P02 AMENDMENTS FOR TENDER:

PROJECT
Natural History Museum
NHM UNLOCKED
THAMES VALLEY SCIENCE PARK

TITLE
SITE WIDE PUBLIC REALM HARDWORKS - PAVING, FURNITURE AND LIGHTING PLAN 1/2

Drawing Number: RD001-FCB-XX-XX-DR-L-3101

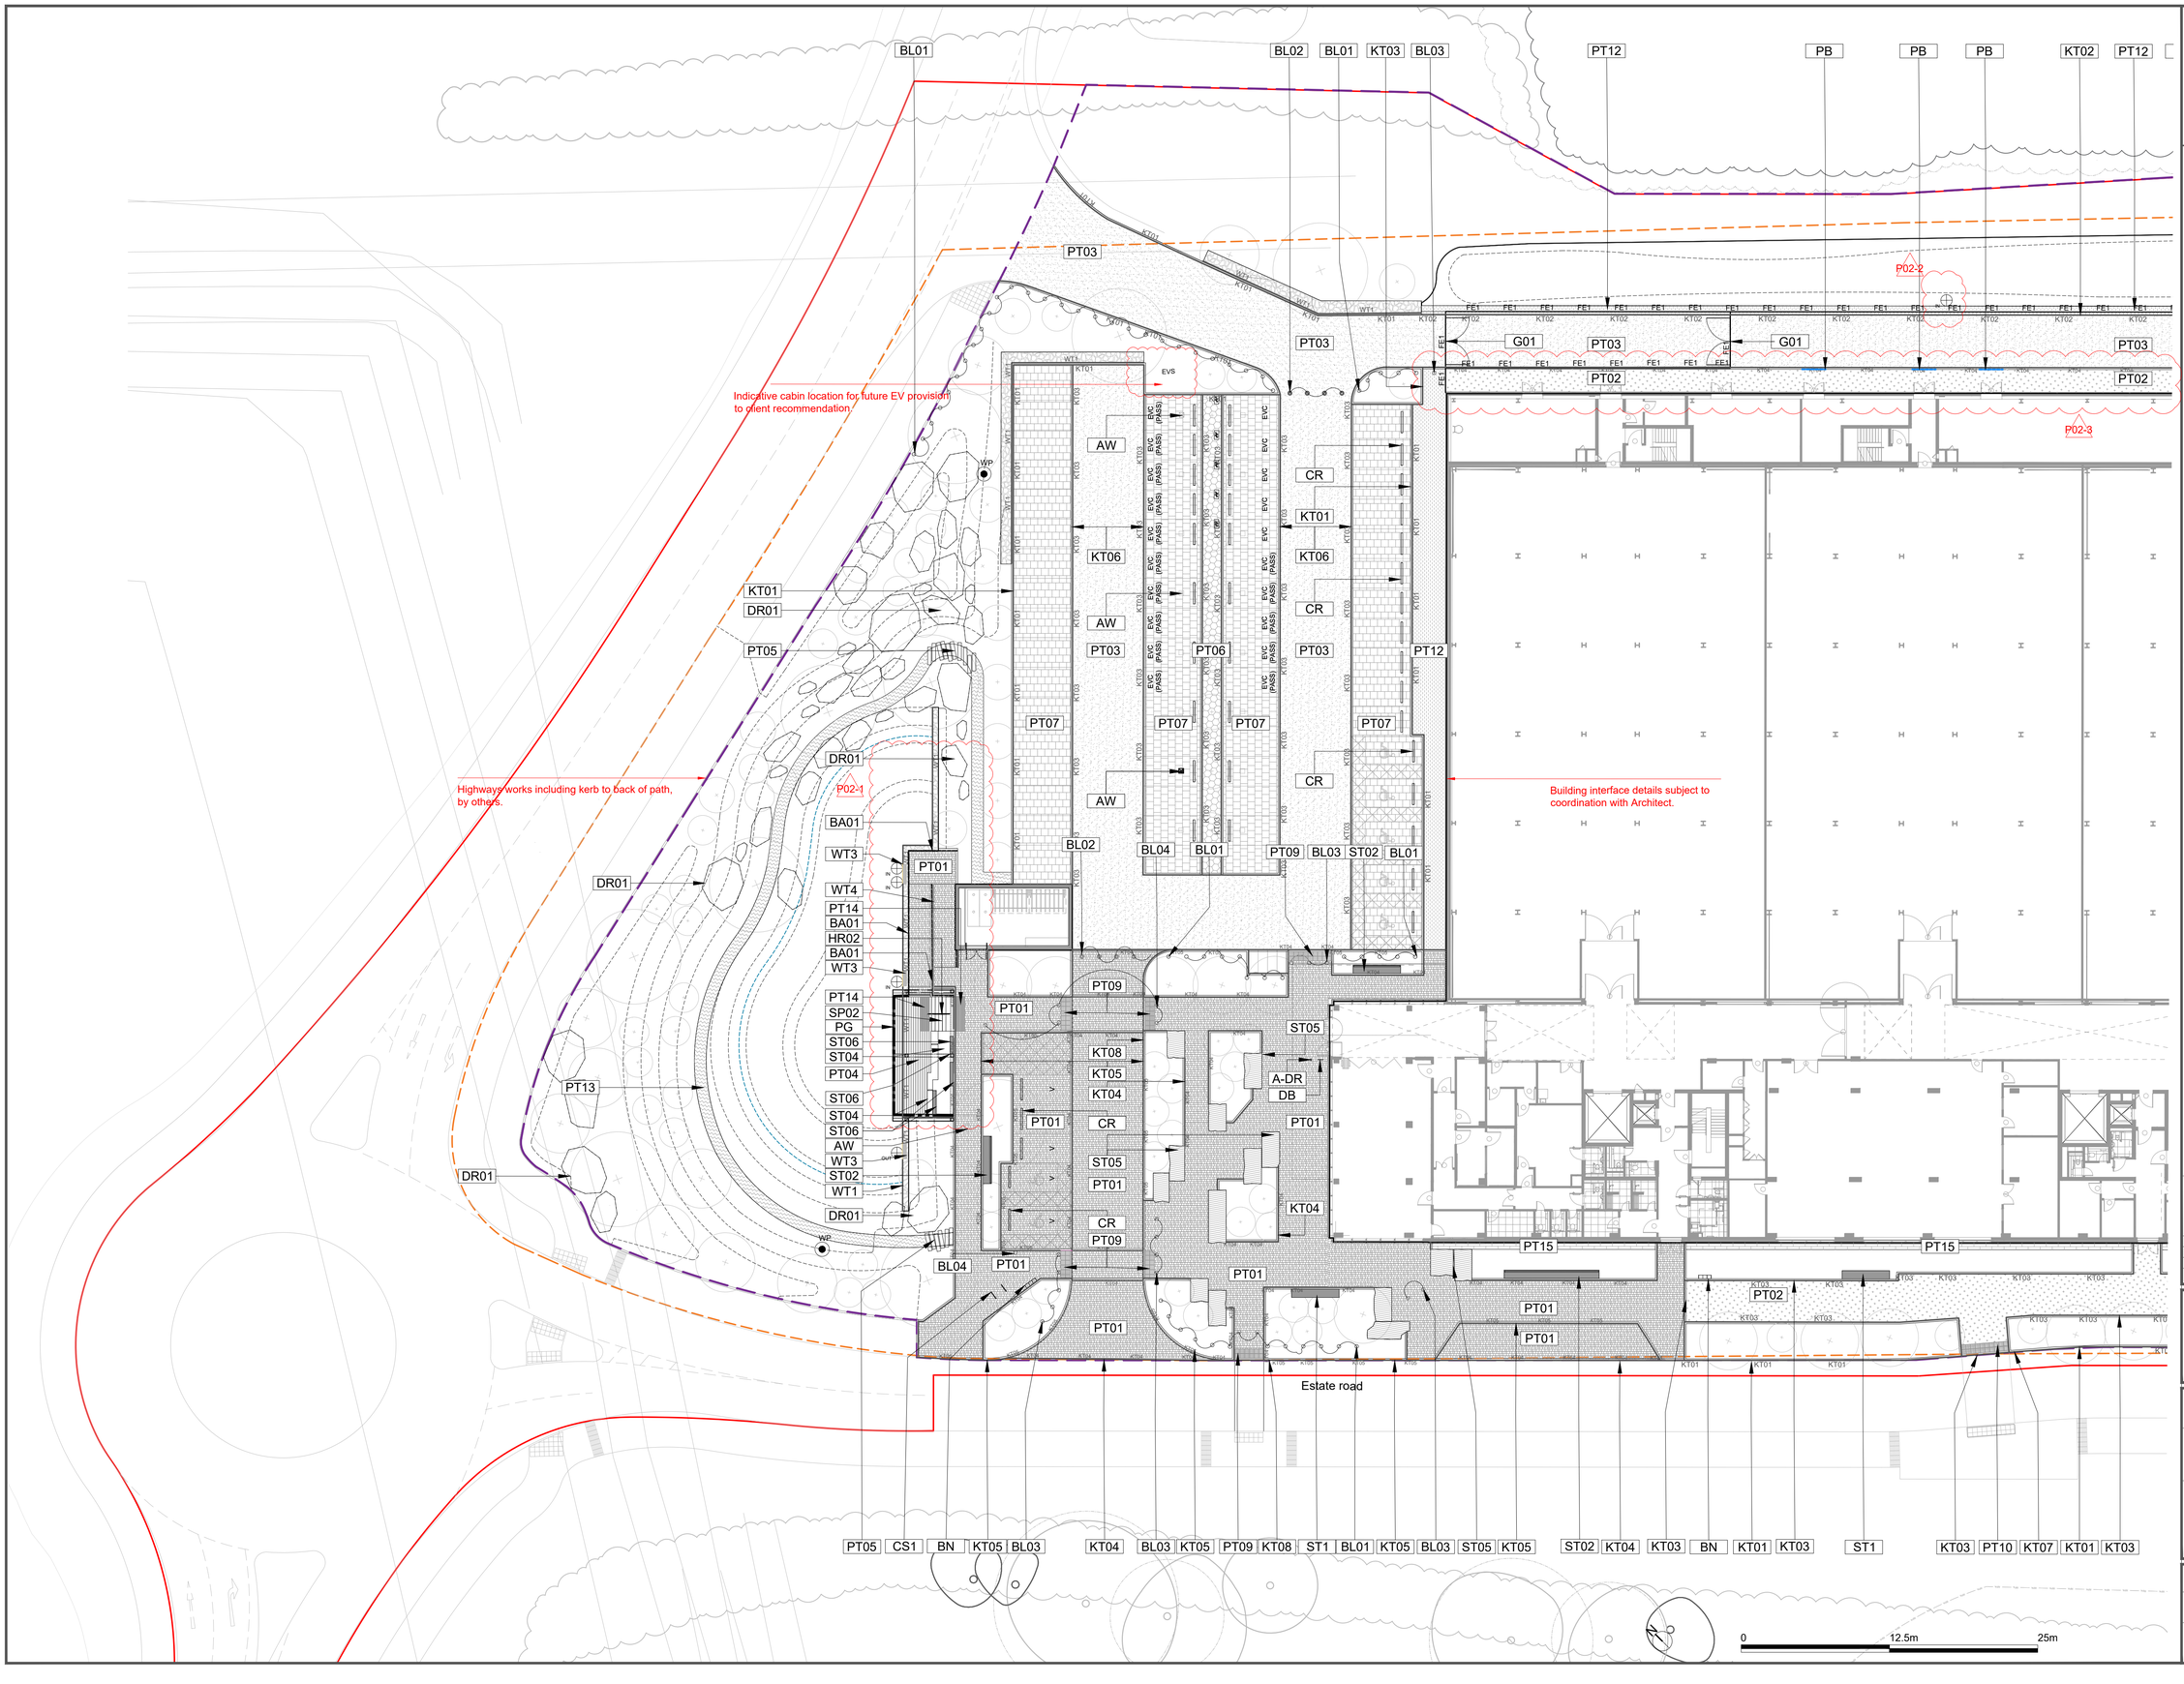
1. Deck and pergola design updated to allow new access ramp. Drawing to read in conjunction with design intern drawings RD001-FCB-XX-XX-DR-L-5301 & RD001-FCB-XX-XX-DR-L-5302 and landscape specification

Changes includes:

A. Access ramp for lower deck.
B. New wall type 04 (WT04) for ramp access structure with balustrade (BA01)
C. New wall type 03 - Precast concrete for headwall inlet and outlet details. Refer to DRW. RD001-FCB-XX-XX-DR-L-5302
D. Upper deck layout updated for wheelchair users.
E. Single stair access (SP02) with single handrail (HR02)
F. Backrest and armrest added to the seating steps. Refer to landscape specification.
G. Pegola layout updated. Refer to DRW. RD001-FCB-XX-XX-DR-L-5302
H. Inlet and Outlet drainage location.

2. New inlet and outlet water drainage locations added in the East and South swales.

3. Paving type updated (PT02) to support vehicular loading.Pedestrian barriers (PB) added in proximity of doors entrances for safety.
